GGG-S-0065B(GSA-FSS)
AMENDMENT-1
August 16, 1976
SUPERSEDING
Interim Amendment-3
June 11, 1964

INTERIM FEDERAL SPECIFICATION

SAWS, HAND

FIGURE 10A - Standard blade dimensions

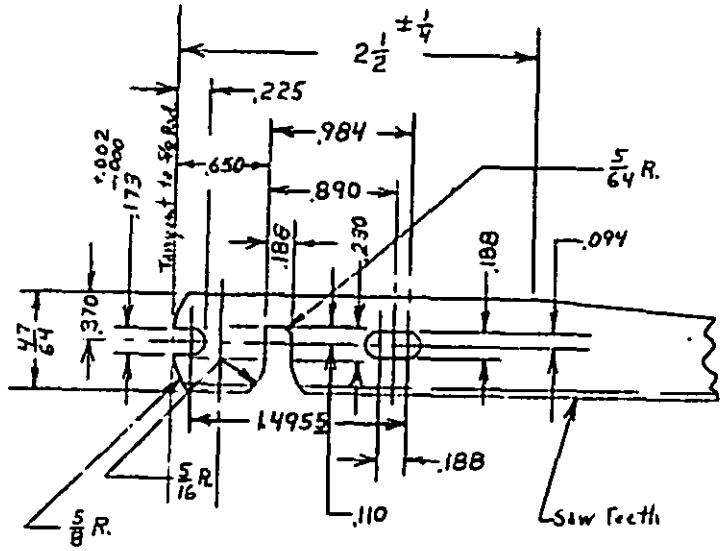
Paragraph 3.16.2: Delete and substitute: "3.16.2 Style B, metal-cutting keyhole saws shall consist of a pistol-grip type handle and detachable metal-cutting blade. Blade teeth shall have a Rockwell "C" hardness of 58 to 62 and shall be capable of passing the metal cutting test in 4.4.2.2. The pistol grip handle shall be designed to position, lock and cut with the blade in each of four different cutting positions (up, down, right, and left). For interchangeability and standardization between handles and replacement blades, all blades shall conform to the dimensions of figure 10A and table VIII.

FIGURE 10 - Type VIII, Style B
keyhole saw - metal cutting

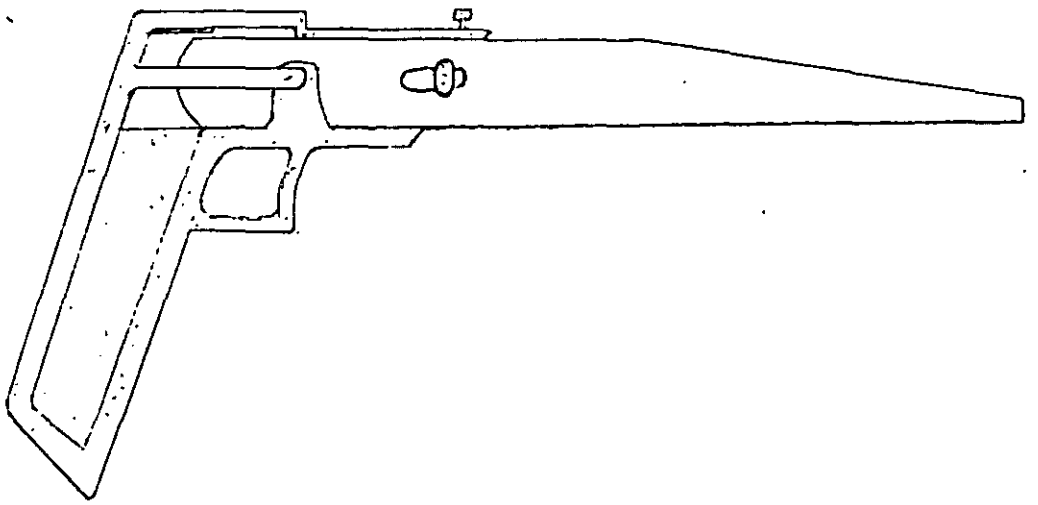
Delete Figure 10 and substitute:
